## **Arlington Zoning Board of Appeals**

2. Docket # 3727: 201 Old Spring Road

3. Docket # 3715: 39 Woodside Lane (Continuance)

RE: Docket 3715 – 39 Woodside Lane; Special Permit under Zoning Bylaw 5.4.2.B(6) Districts

Below are aerial and street-based photos of the current building:

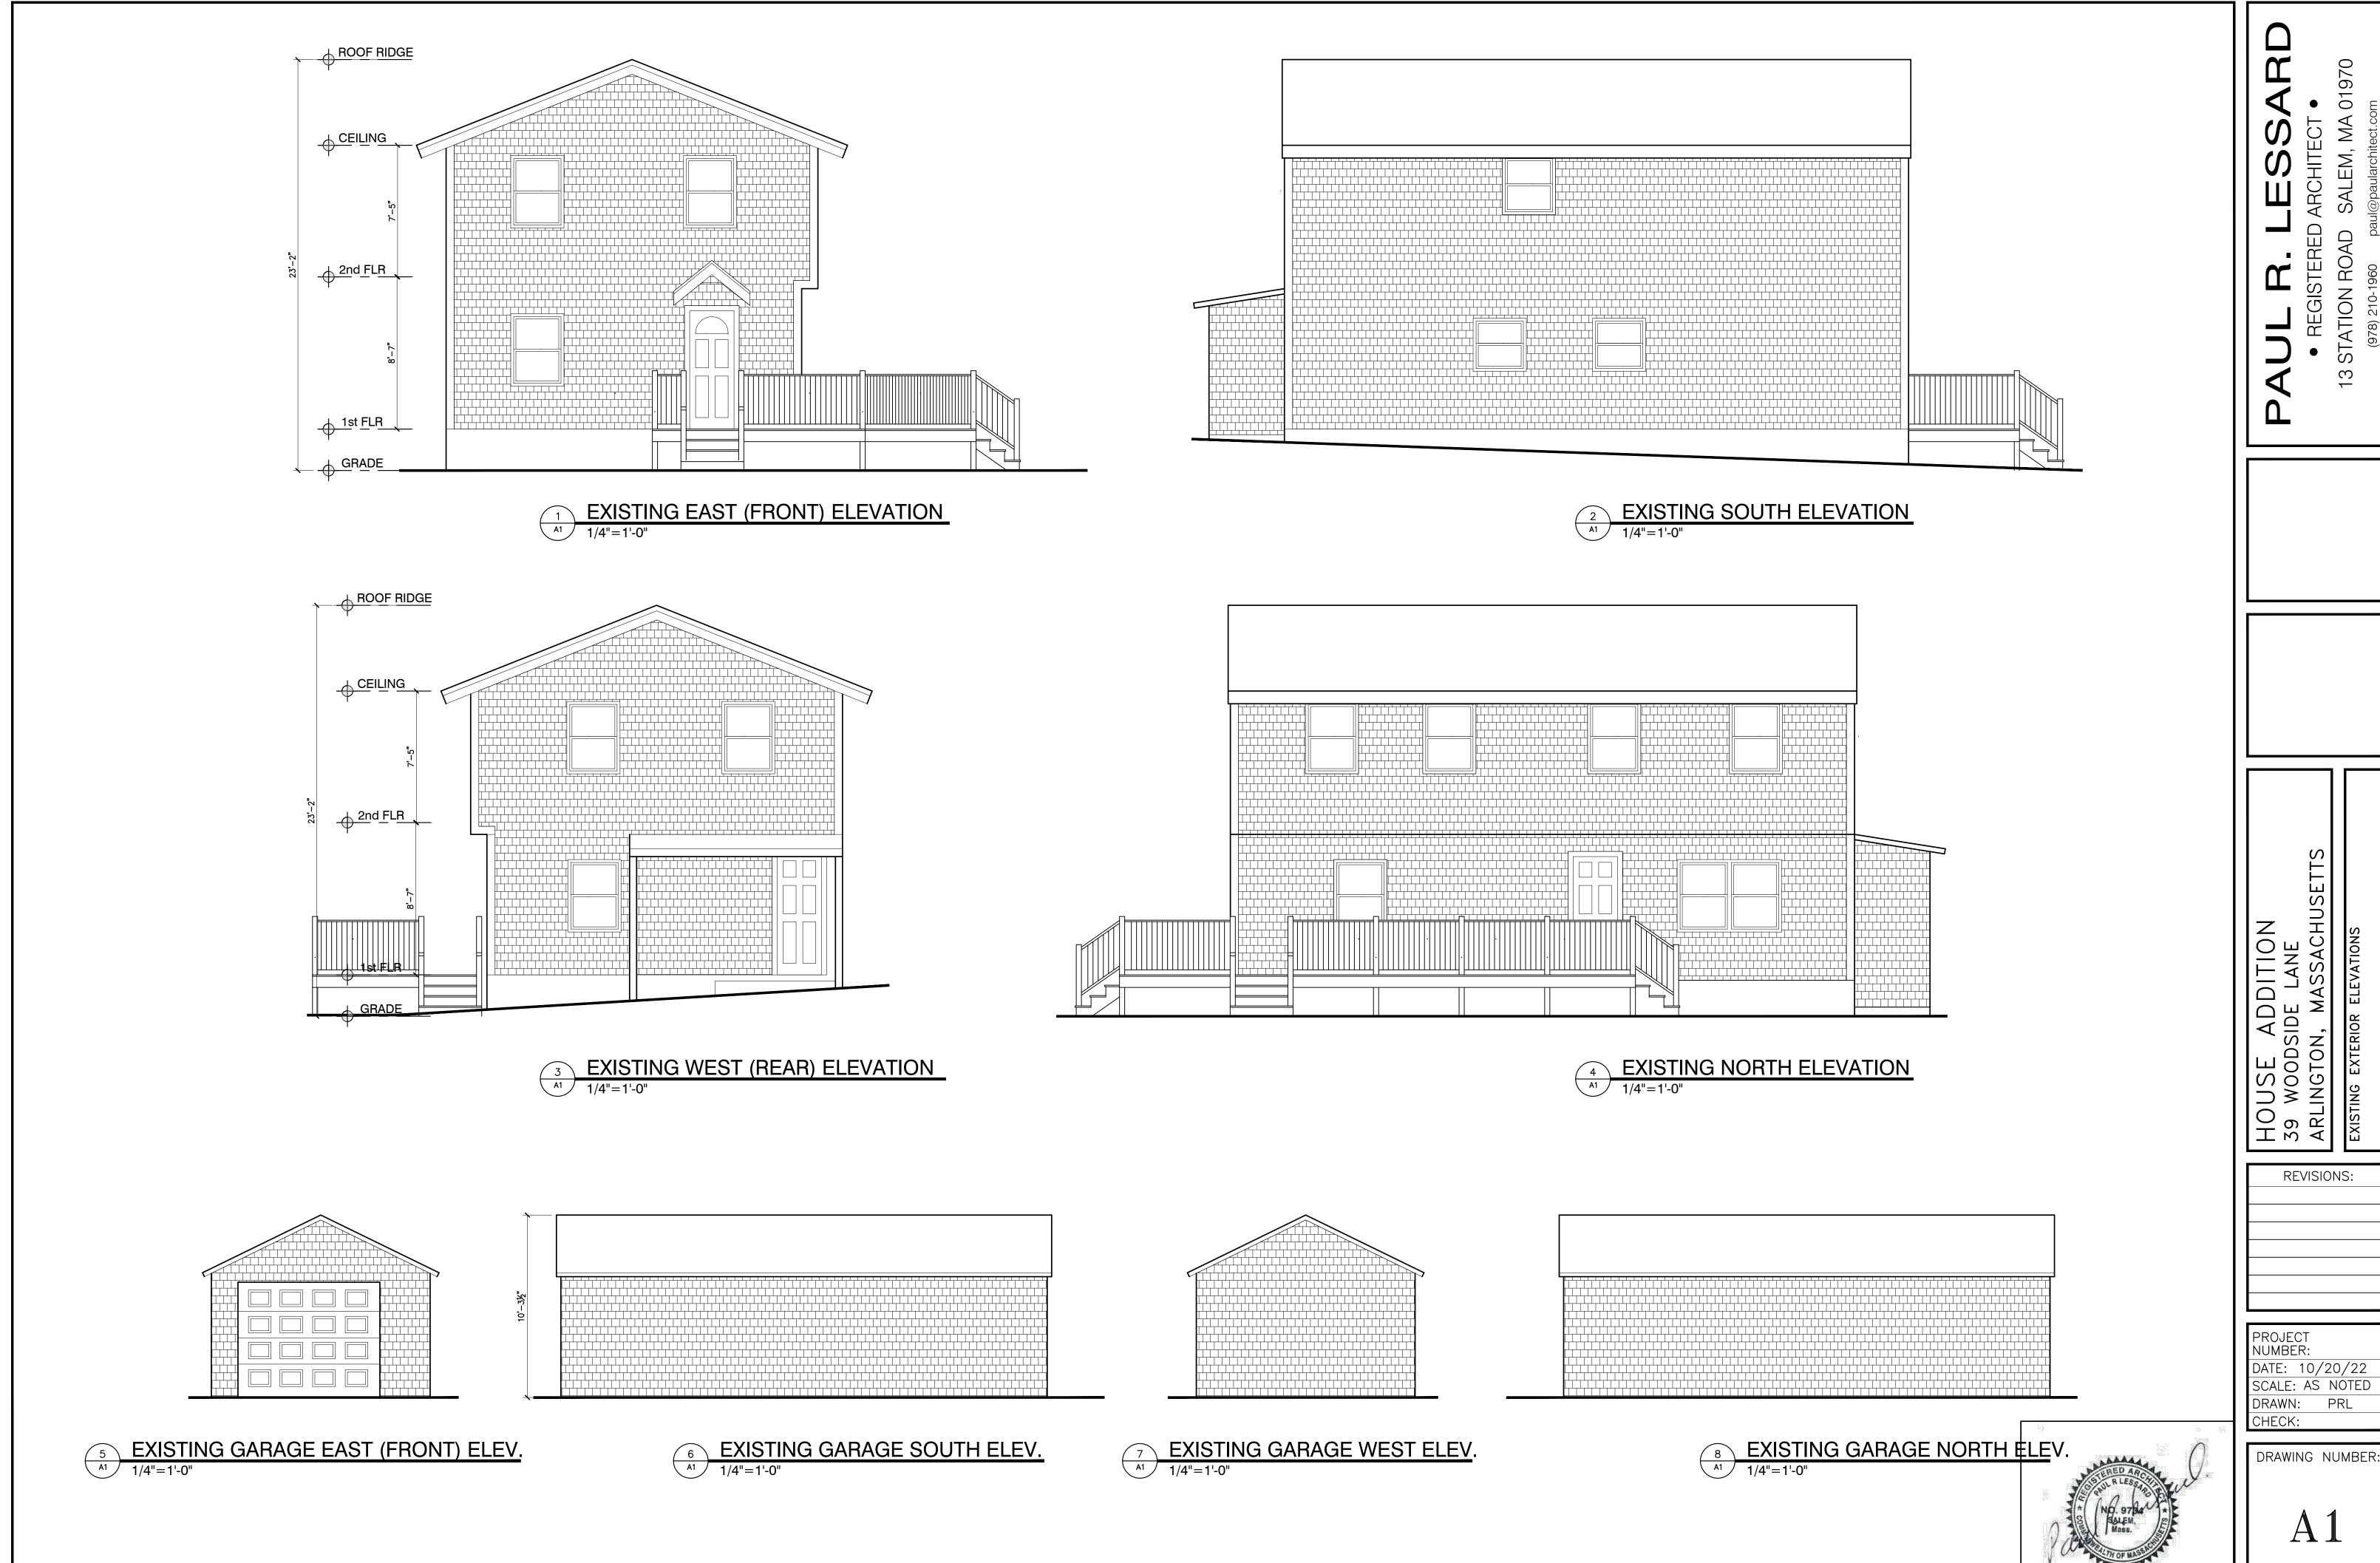
The application states the proposal would increase the gross floor area of the attic to 769 SF (+431 SF). Per the definition of a half story in Section 2 (Definitions) of the Zoning Bylaw, "less than one half of the floor area measured from the underside of the roof framing to the finished floor below has a clear height of 7 feet 0 inches or more." It is unclear based on the materials submitted by the applicant whether a half story is proposed and if so, whether the dimensions of the finished floor area would comply with this definition.

Criterion #6: Integrity/Character of District; Detrimental to Health, Morals, Welfare Homes in the vicinity of the property include a range of architectural styles, typically Colonial/Ranch styles and smaller typologies like Capes. The addition is designed to complement the scale of the existing structure as well as the style of adjacent homes in the neighborhood. Although the proposal does not interrupt the existing streetscape pattern, the applicant is encouraged to explore the potential to adjust the exterior composition of the front façade including window placement.<sup>1</sup> Overall, this proposal would not detrimentally impact the neighborhood character of the district or adjoining districts, nor will it be detrimental to the health, morals, or welfare of the neighbors of the property.

DPCD recommends that the Zoning Board of Appeals (ZBA) requests that the applicant provide attic floor plans to clarify dimensions of the finished floor area and side elevations.

### 39 WOODSIDE LANE TREE PLAN

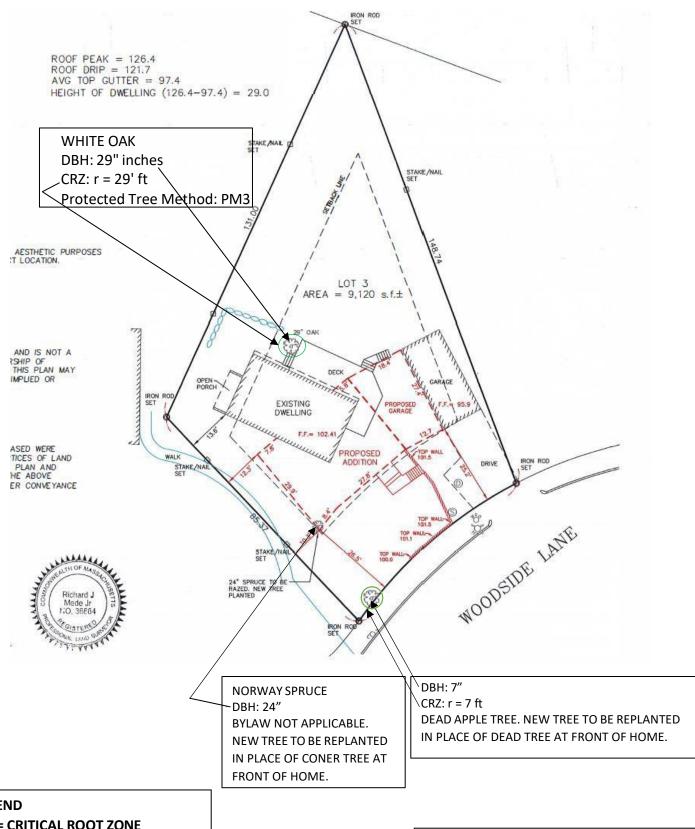
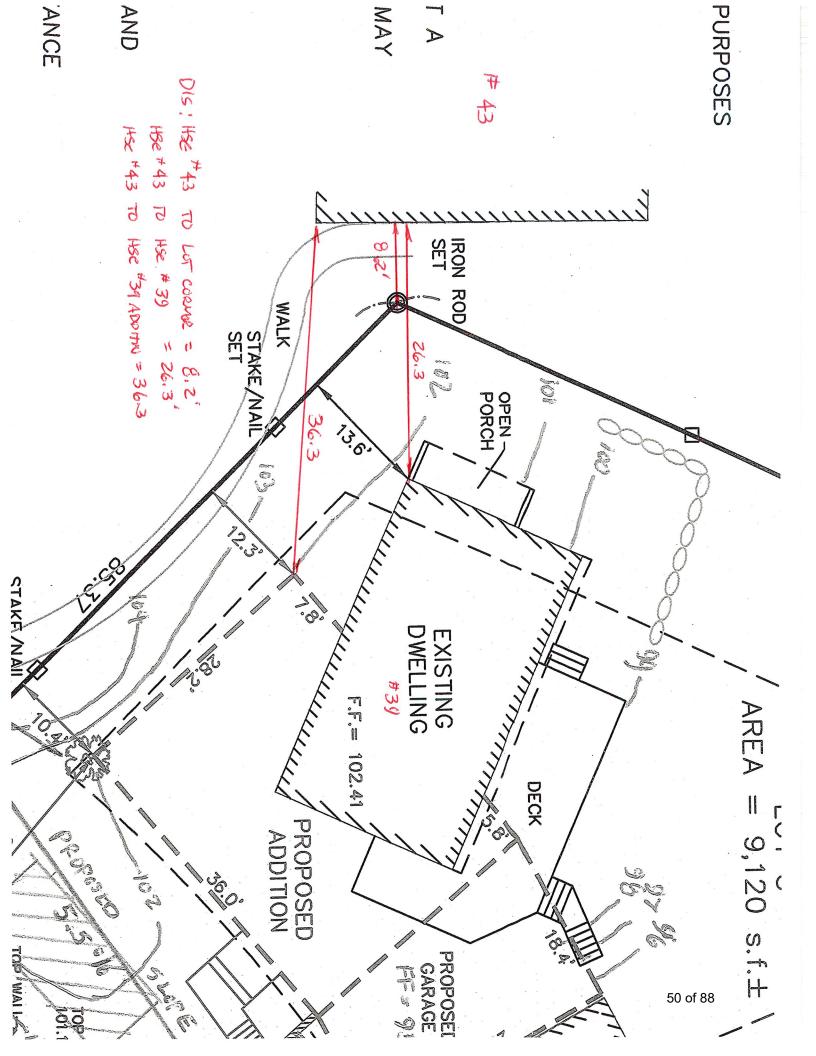
Thank you for submitting your Tree Plan to comply with, Article 16 "Tree Protection and Preservation." The trees in the 'Setback Area' measuring 8" (DBH) Diameter at Breast Height or larger have been identified on your plan. There are no qualifying trees to be removed according to your plan.

The Tree Plan you have submitted is consistent with the requirements of the Bylaw, I approve your plan and commencement of work.
